MFN 03-064
Enclosure 2

Response to NRC RAI numbers (187, 190, 191, 195, 202, 220,
225, 231, 232, 272, 296, 297, 327, 334–338, 345, 347, 349-
359, 371-376, 378, and 379)

Enclosure 2 RAIs NEDC-33079P “ESBWR Test and Analysis Program Description”

Figure 187A GDCS Equalization Line

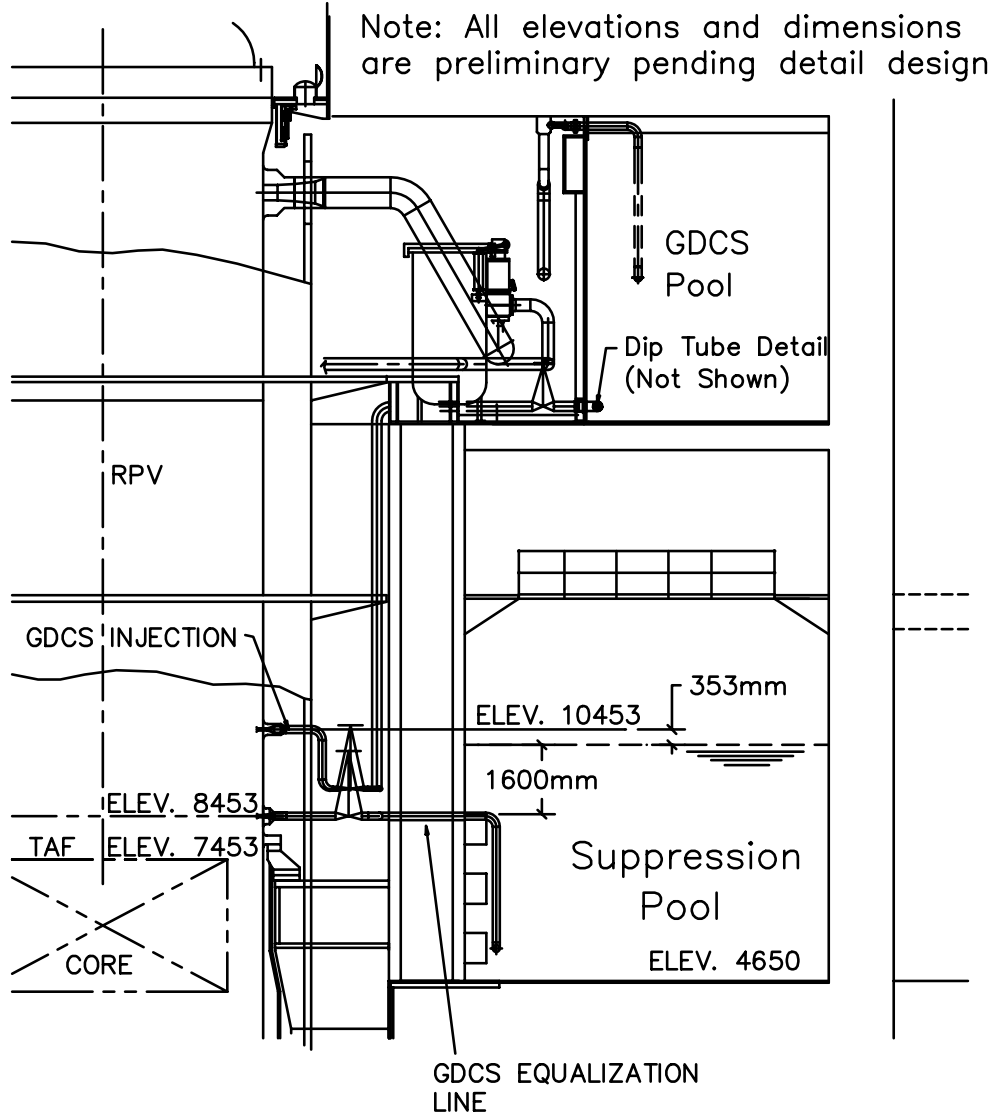
Q187. Page 2-5, Section 2.2.1.2 - For the last paragraph an elevation diagram would be helpful to the discussion.

R187. Please see Figure 187A and Figure 187B for details.

Figure 187B Spillover Hole Configuration

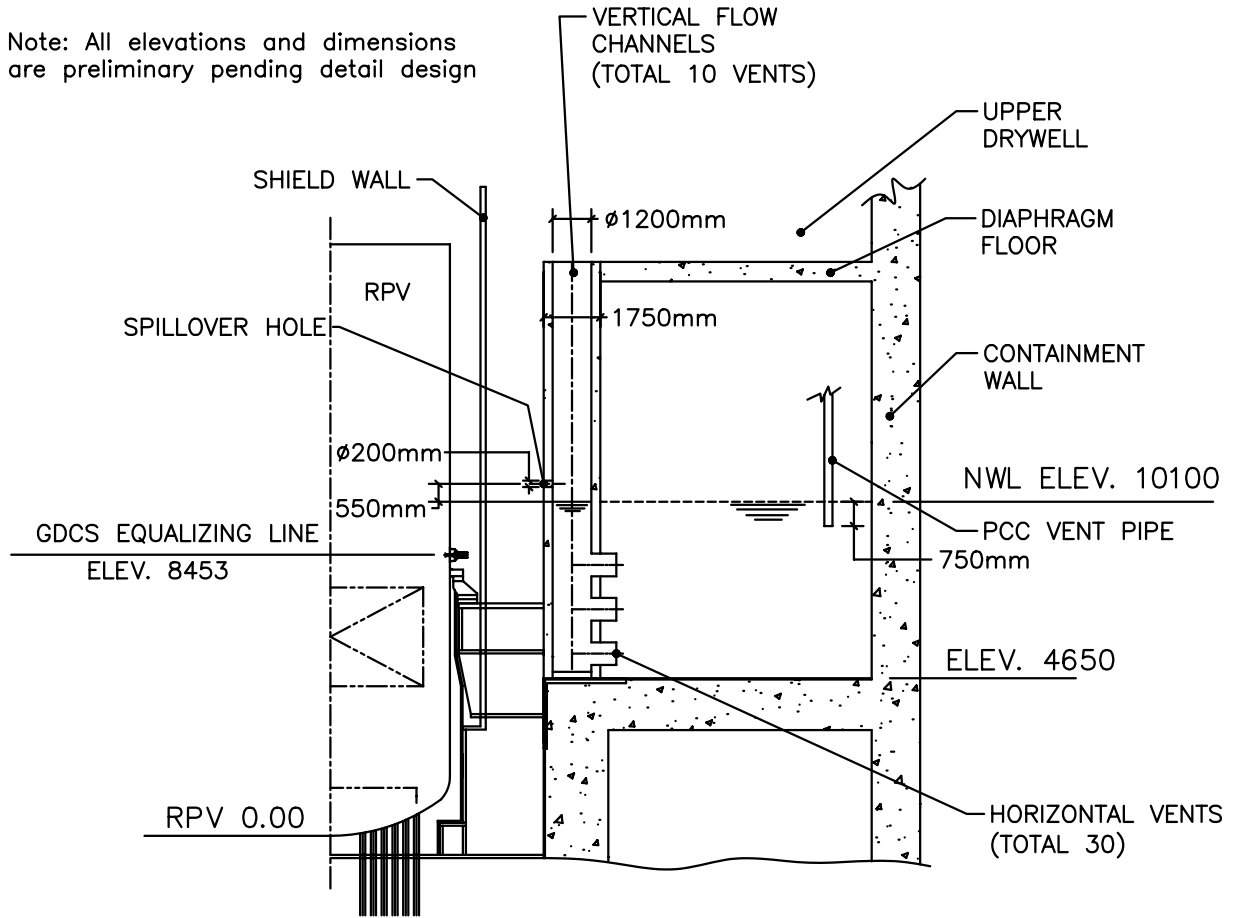
- Q190. Page 2-9 (last paragraph) - It is stated that water collected in the drywell can spill into the wetwell through the spillover holes in the pipes connected to the horizontal vents. Please provide a sketch to show the elevation and diameter of the spillover holes and explain why their presence will not adversely affect horizontal vent clearing in a loss of coolant accident (LOCA).

- R190. Please see Figure 187B (above) for details of the spillover holes. The holes lead from the annular region of the drywell (region surrounding the RPV) to the vertical vents, which lead to the horizontal vents under the water surface of the suppression pool. The spillover holes are 200 mm in diameter and are located about 550 mm above the normal level of the suppression pool water. One hole leads into each of the ten vertical vent pipes. The spillover holes provide a return path for water, which may accumulate in the lower drywell and the annular region of the drywell during a pipe break accident. The purpose of the spillover holes is to provide a means to limit the draw-down of the suppression pool water and thereby assure the PCCS heat exchanger vent submergence. Since the spillover holes are located above the normal water level in the vertical vents they have no impact upon the vent clearing process. The drywell atmosphere pressurizes the vertical vent water column and forces this level down to the first, second and sometimes even third horizontal vents in order to clear the vents and relieve the pressure differential.

Figure 202A ESBWR RPV

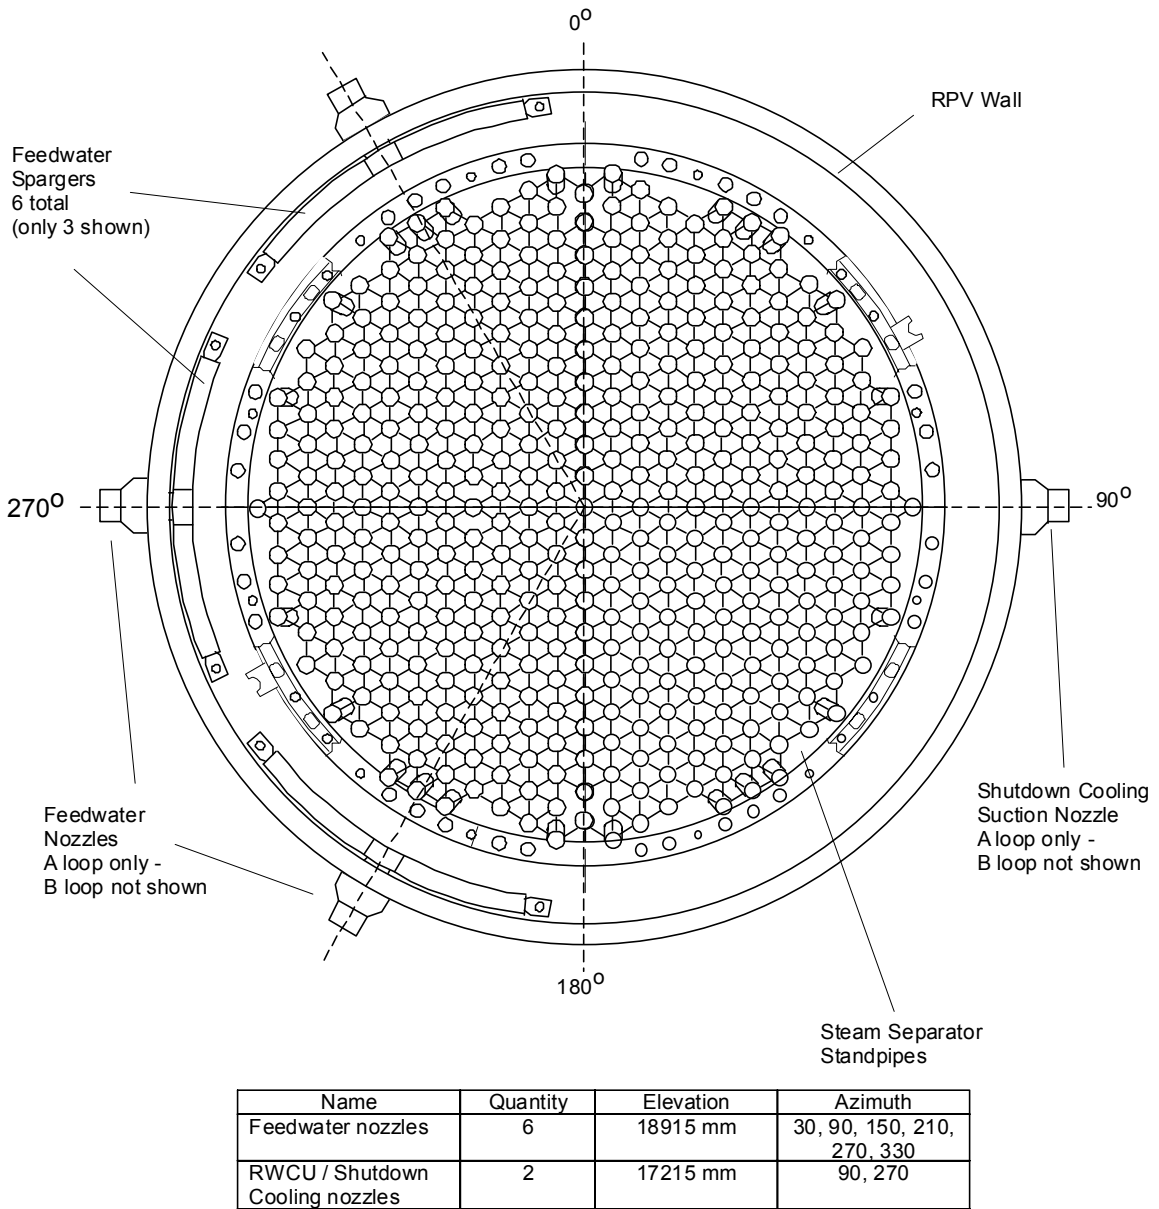
Q202. Page 3-27 (No.2 - B11/4) - It seems that the suction lines of the Reactor Water Cleanup/Shutdown Cooling (SDC) System are connected either to the RPV downcomer annulus or to the RPV bottom head and the injection lines are connected to the RPV via the main feedwater lines. (1) Please provide a sketch to show “inlet and outlet nozzles located diametrically across the downcomer.” (2) There is a typographical error in the fourth column, “CFD code calculations show sort [sic] circuiting will not occur” should be replaced with CFD code calculations show short circuiting will not occur.

R202. Please refer to Figures 202A and 202B for details of the shutdown cooling suction nozzle and the feedwater nozzles.

Figure 353.1. RPV Collapsed Level in Test P1/8

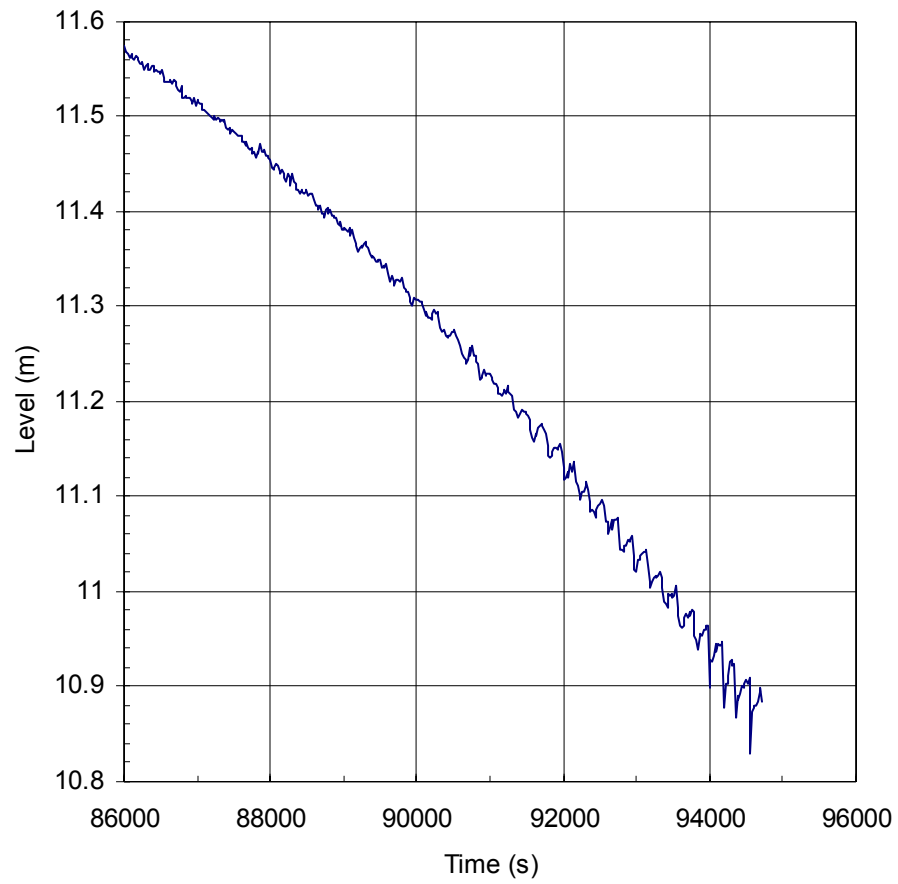
Q353. ALPHA-716-0/Page 20 (Fig. 5). [[

R353. [[

Figure 359.1. Main Vent 1 Instrument Locations

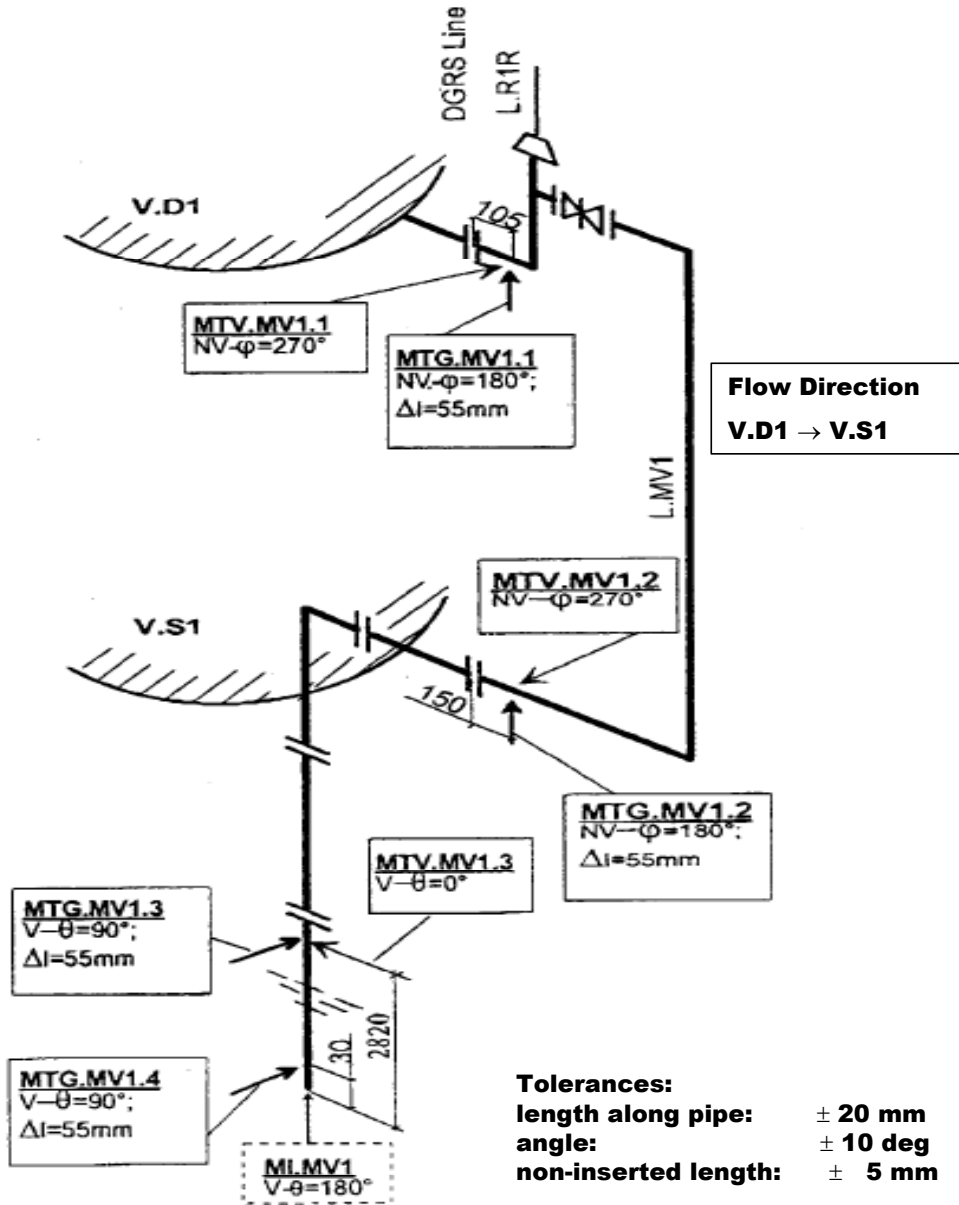
Q359.1. Please provide an instrumentation diagram to show where these main vent thermocouples were located.

R359.1. The main vent instrument locations are shown in Figures 359.1 and 359.2. The thermocouples used to measure gas temperatures are identified as MTG.MV1.1 - 4 and MTG.MV2.1 - 4. Dimensions are in millimeters.
